Access Compliance Report

Public Rights-of-Way

(Curb Ramps)

Intersection ID: 7186	Main Street: BEATTIES_FORD_RD	Cross Street: FAIRDALE_DR	Location: NW
ADA ID: A24BC2B9B9D3	Ramp Type: Perp	Initial Pass/Fail: Fail	Overall Compliance: No
Severity Score: 33.75			
Codes/Mitigation Info/Possible Solution		Field Measurements/Component Compliance

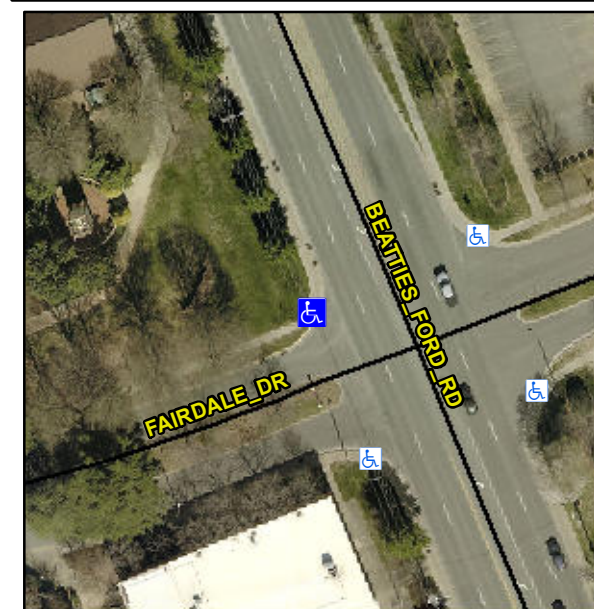
Not Found, R304.5.1, R304.2.2

Compliance	Description	Data	Compliance	Description	Data
N/A	Ramp Length (in)	59.5	No	Ramp Slope (%)	12.5
No	Ramp Width (in)	46.0	Yes	Ramp XSlope (%)	0.5
N/A	Flare Type LT	N/A	N/A	Flare Type RT	N/A
N/A	Flare Slope LT (%)	N/A	N/A	Flare Slope RT (%)	N/A
N/A	Flare Traversable LT?	N/A	N/A	Flare Traversable RT?	N/A
N/A	Landing Length (in)	N/A	N/A	DWS Provided?	N/A
N/A	Landing Width (in)	N/A	N/A	DWS Contrast?	N/A
N/A	Landing Slope (%)	N/A	N/A	DWS Length (in)	N/A
N/A	Landing X Slope (%)	N/A	N/A	DWS Full Width?	N/A
N/A	Landing Curb? (Y/N)	N/A	N/A	DWS Offset (in)	N/A
N/A	Shared Landing?	N/A			
N/A	Gutter Ponding?	N/A	N/A	Gutter Slope (%)	N/A
N/A	Gutter Lip Ht (in)	N/A	N/A	Gutter X Slope (%)	N/A
N/A	Painted X Walk1?	No	N/A	Painted X Walk2?	N/A
	X Walk 1 Direction	To SE		X Walk 2 Direction	N/A
N/A	X Walk 1 Width (in)	N/A	N/A	X Walk 2 Width (in)	N/A
	X Walk 1 Slope (%)	1.3		X Walk 2 Slope (%)	N/A
	X Walk 1 X Slope (%)	6.5		X Walk 2 X Slope (%)	N/A

Remove & Replace Entire Ramp.
